### Planning Commission

Wednesday, September 21, 2022

**TECHNICAL REVIEW PLAT REQUIREMENTS  
REGULAR PLANNING COMMISSION MEETING  
September 21, 2022**

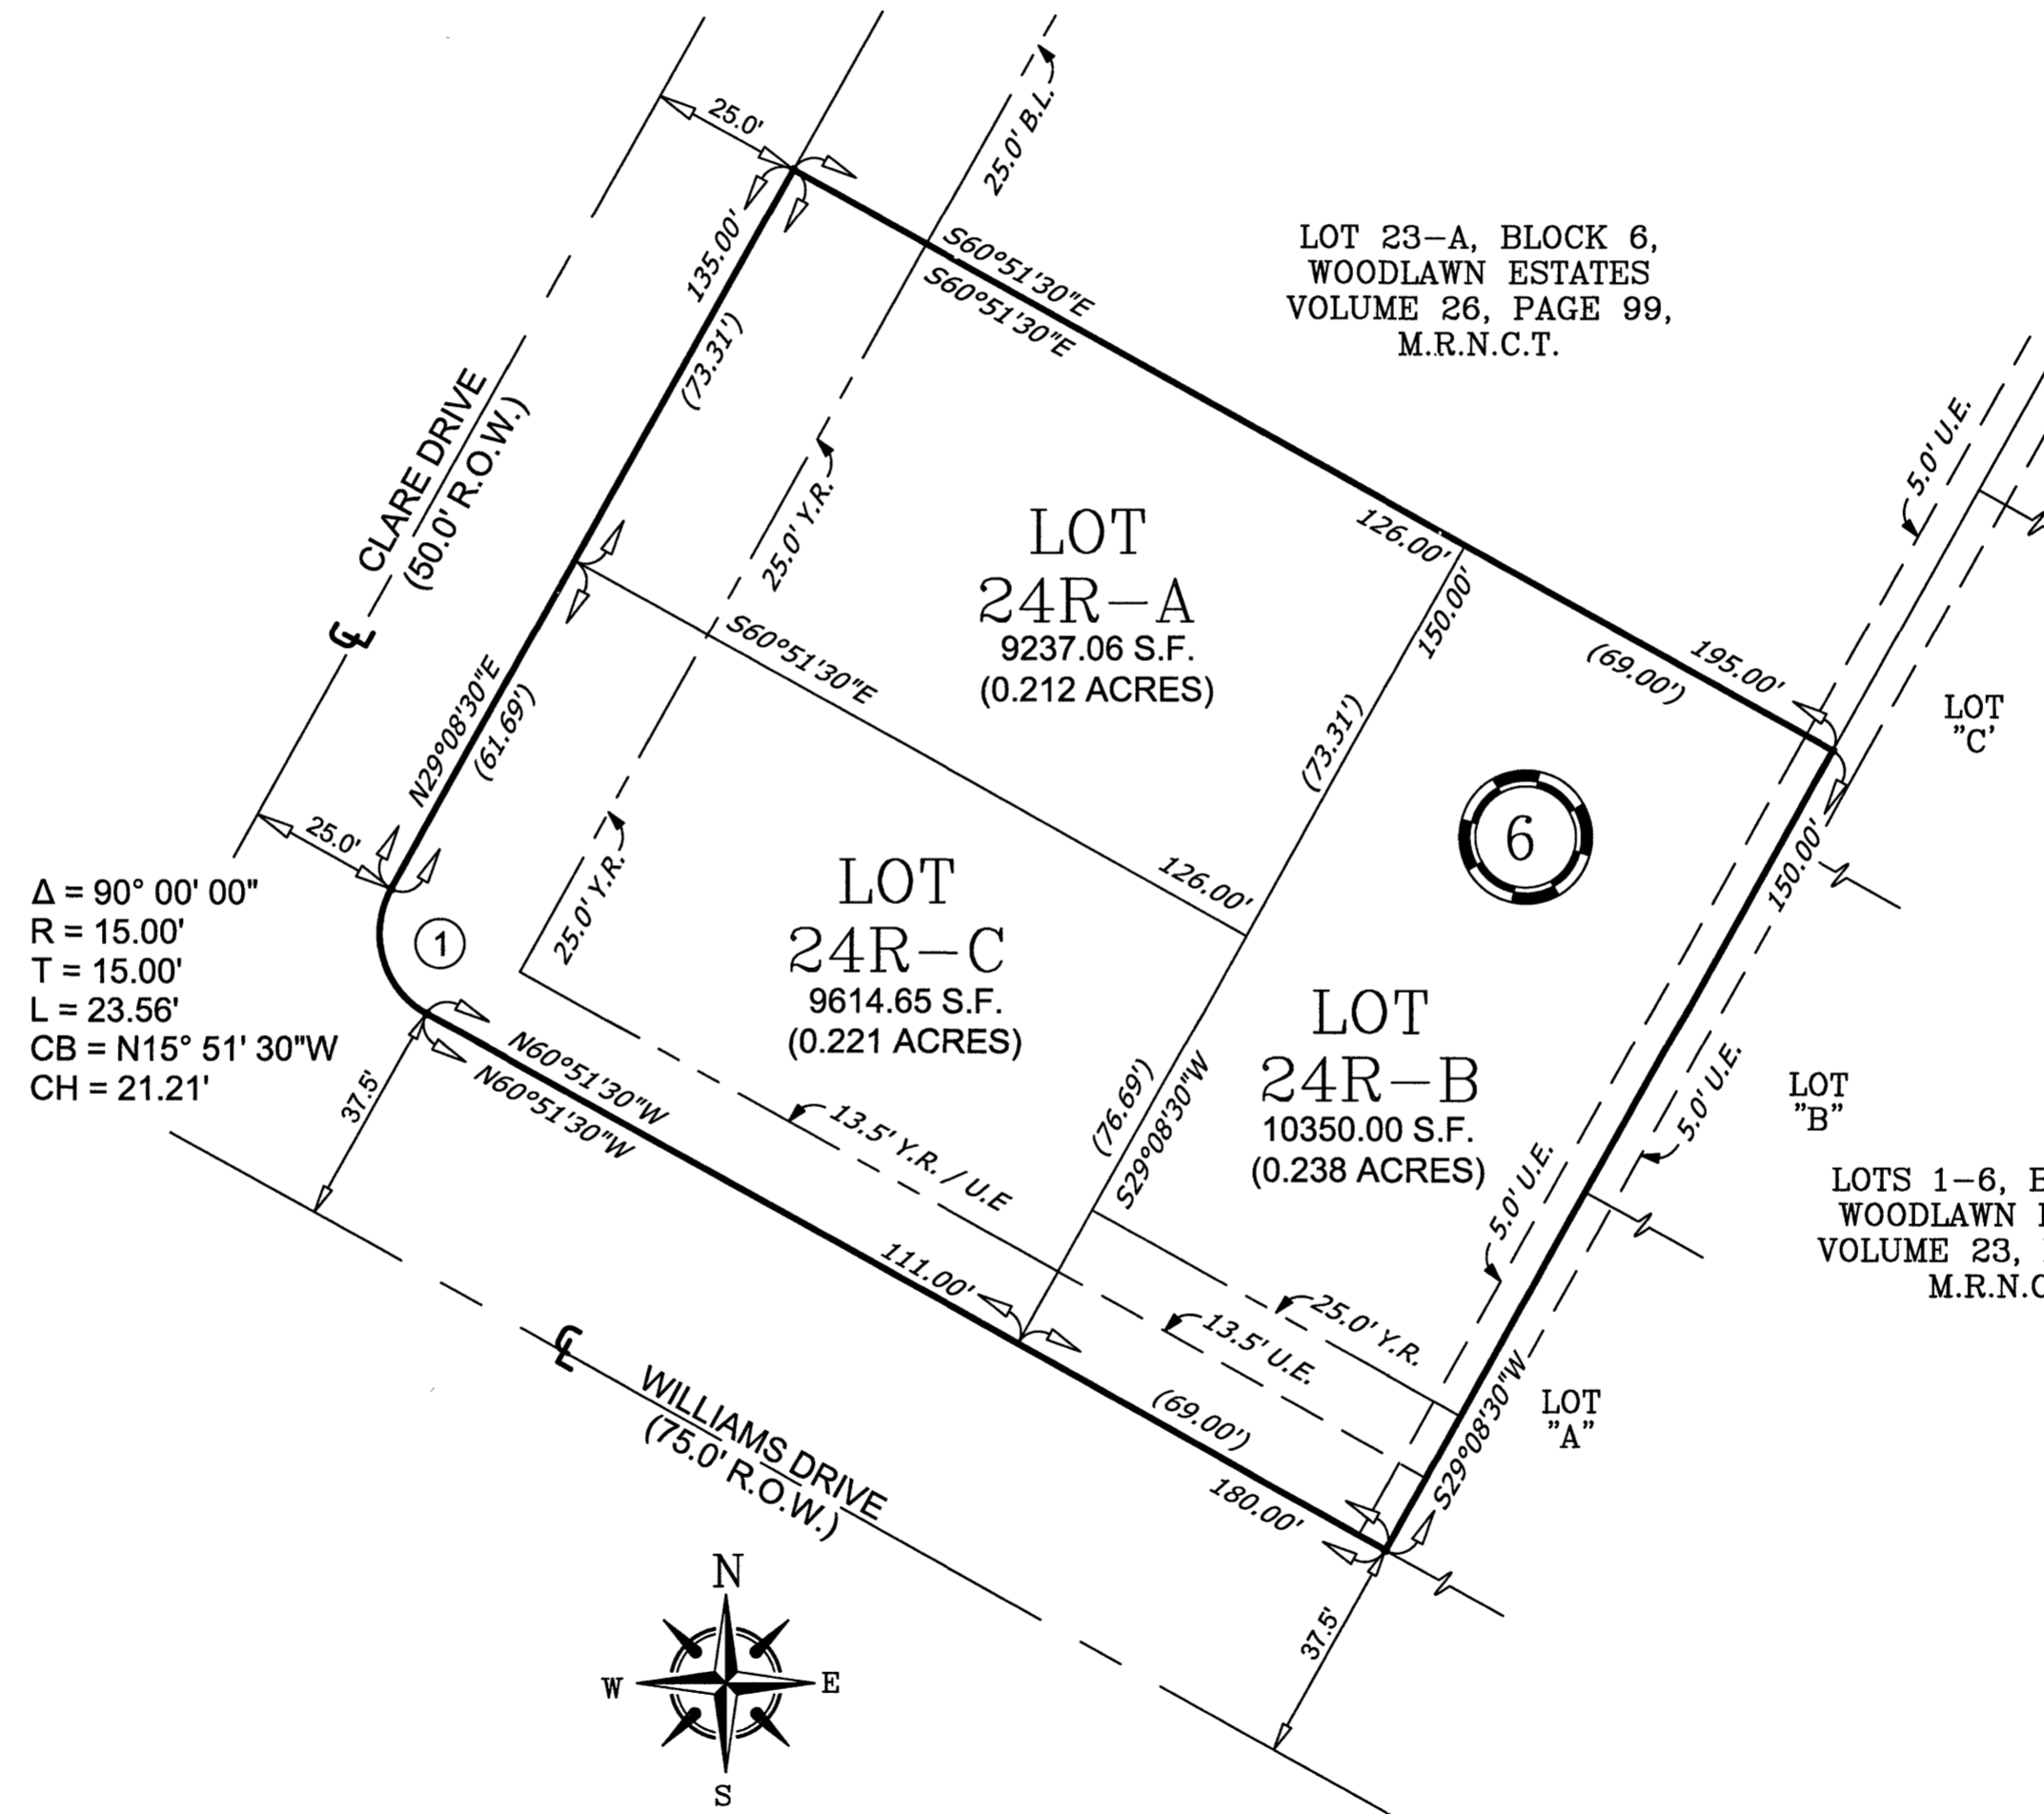
LAND DEVELOPMENT						
No.	Sheet	Comment	Applicant Response	Staff Resolution	Applicant Response	Staff Resolution
1	Plat	Lt 24R-C yard requirement along Williams shall be 17.5'. Please relabel the yard requirement. (UDC Section 4.2.10 Adjacent lots)	Utility and Yard Requirements along Williams Drive offset 3.5 feet North-East to accommodate encroachment on Lot 24-R for Williams Drive Improvement Project	Addressed as per response, however, submit a revised plat showing Lot 24R-B front yard requirement returned to 25' as per zoning district.	Revised on plat showing Lot 24R-B front yard requirement returned to 25' as per zoning district. (15 AUG 2022)_01	Addressed
